TECHNICAL BULLETIN

407-20-135

SUBJECT: AUTOMATIC FLIGHT CONTROL SYSTEM (AFCS),
MODIFICATION OF

HELICOPTERS AFFECTED: Serial numbers 54304, 54567, 54805 through 54903, 54905 through 54906, 54908 through 54910 and 54912 with 407-706-061-103 or 407-706-061-107 AFCS kit installed.

FIGURE 1 – Terminal block, rail and wire harness installation

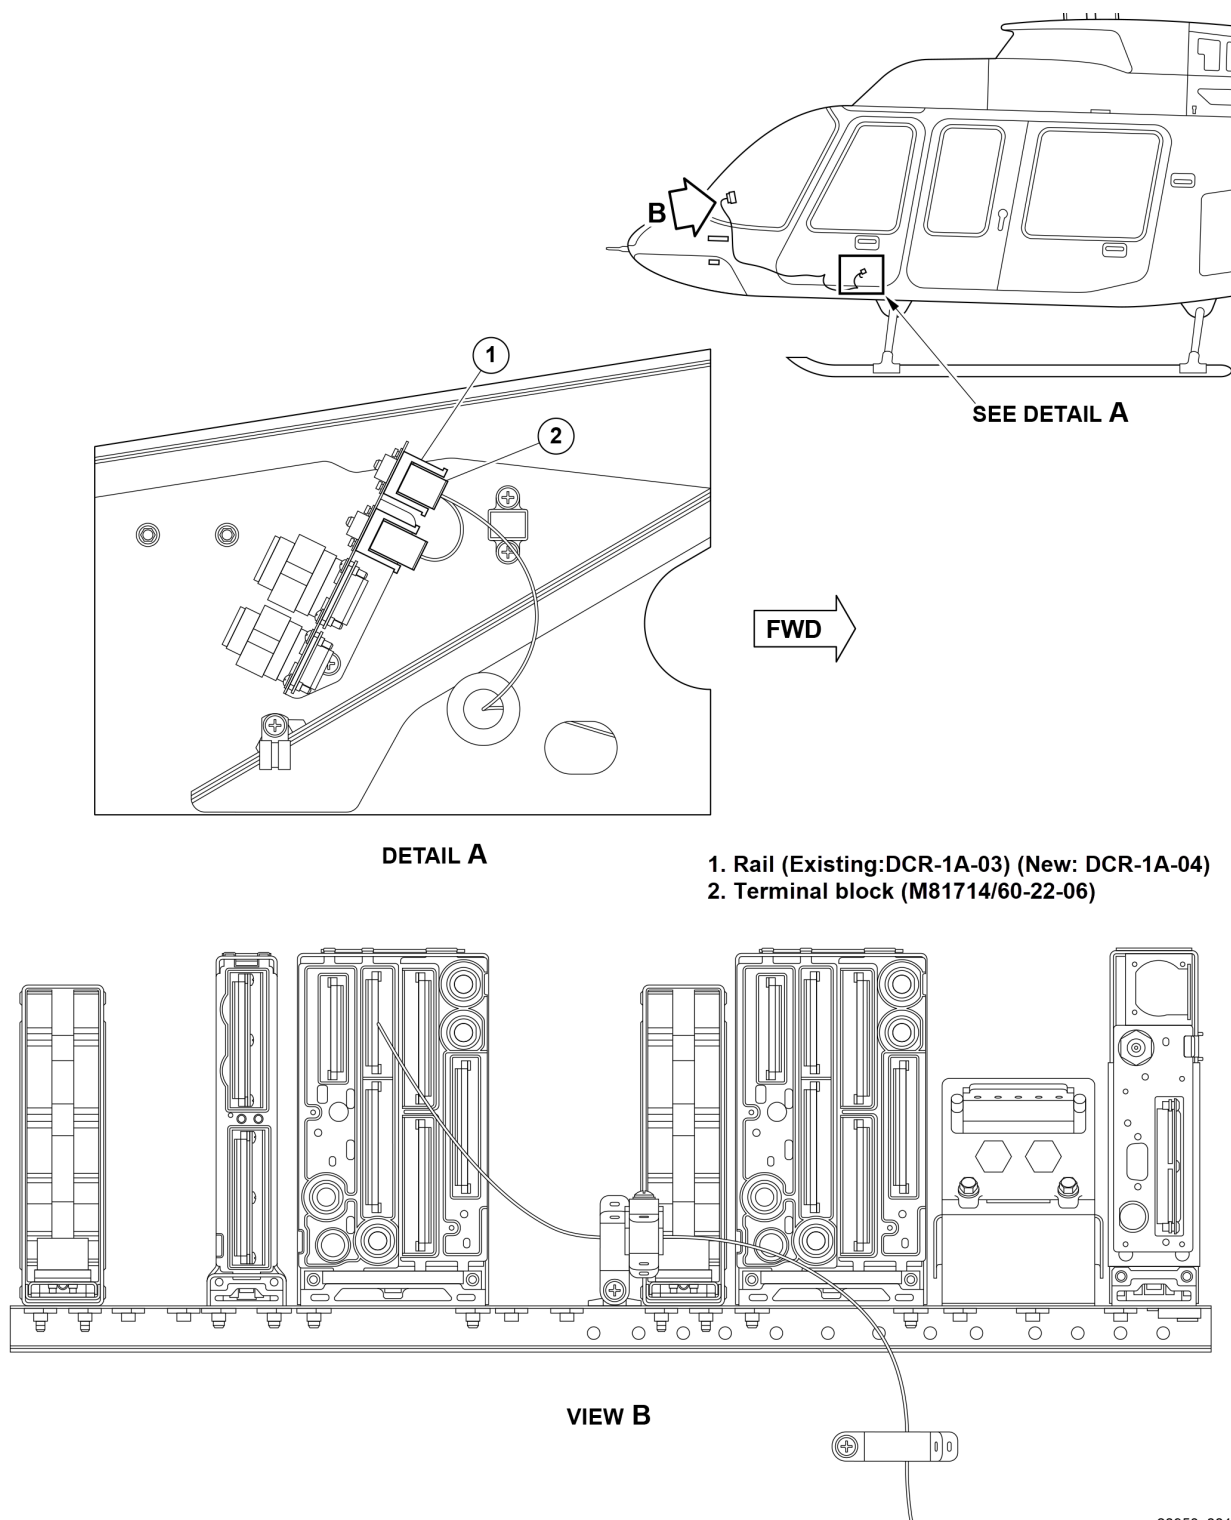
4. Remove terminal blocks 2210TB2K, 2210TB2L and 2210TB2M from the terminal block rail (BHT-ELEC-SPM).
5. Remove and discard the existing rail (1, Figure 1) (BHT-ALL-SPM). Retain the hardware for the installation in step 6.
6. Install the new rail (1) with the hardware that was retained in step 5.
7. Install the new terminal block 2210TB2N (2) on the rail (1). Reinstall terminal blocks 2210TB2K, 2210TB2L and 2210TB2M that were removed in step 4 (BHT-ELEC-SPM).

8. Wire harness modifications instruction (BHT-ELEC-SPM, Chapter 6).
 - a. Retermine existing wire C50B22 from 2210TB2K position N to 2210TB2N position A.
 - b. Cut two pieces of wire to the length specified in table 1. Mark the wire number C50H22 and C50J22 every 6 to 12 inches (152.4 to 304.8 mm) using M23053/5-105-9 heat shrink and a permanent ink marker.
 - c. Crimp contact M39029/22-191 to both end of wire C50H22. Terminate wire C50H22 to 2210TB2K position N and 2210TB2N position B. Secure installed wire C50H22 with cable ties.
 - d. Crimp contact M39029/22-191 to wire C50J22. Terminate wire C50J22 to 2210TB2N position E. Route wire from terminal block 2210TB2N to GIA No.2connector 3140A2P4.

- e. Crimp contact M39029/58-360 to opposite end of wire C50J22. Terminate wire C50J22 to 3140A2P4 position 15.
9. Reinstall the PFD, the GIA No 2, the shroud assembly, the left upper and lower console panel, the pedestal cover, the crew seats, the pilot seat panel and the center panel removed in step 3 (407-MM, Chapter 25 and Chapter 95, BHT-ALL-SPM).

FIGURE 2 – AFCS force trim modification wiring diagram

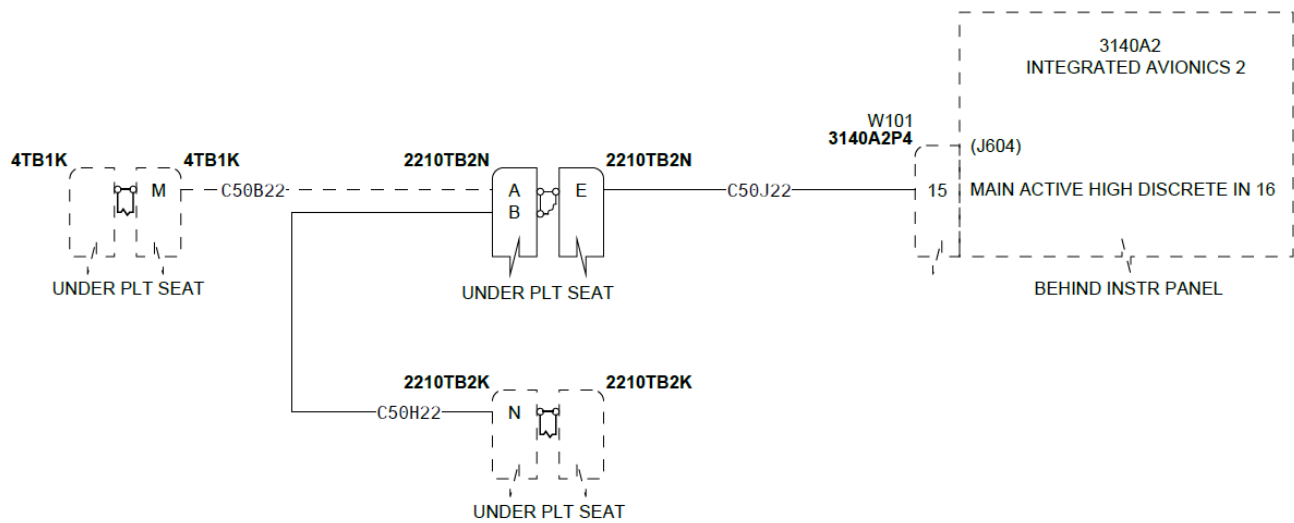
Refer to BHT-ELEC-SPM to complete the following step.
Refer to Figure 1 for wire routing, and Figure 2 for the wiring diagram.
